## SAF PosiLift™ Axle Lift System

### Bolt-On PosiLift™ Axle Lift System now available on fixed frame CBX suspensions

Available June 2015

Figure 1 - New bolt-on bracket

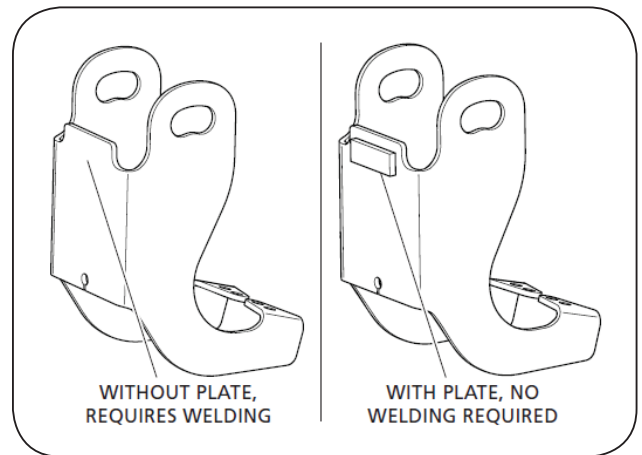
SAF-HOLLAND is pleased to announce that we will launch a new bolt-on PosiLift™ axle lift system on fixed frame CBX suspensions. This new version incorporates a plate that eliminates the need to weld the lift bracket to the suspension (Figure 1). Eliminating the welding operation provides a significant advantage to dealers or end users who wish to add a PosiLift™ lift system to an axle that was not originally equipped from the factory.
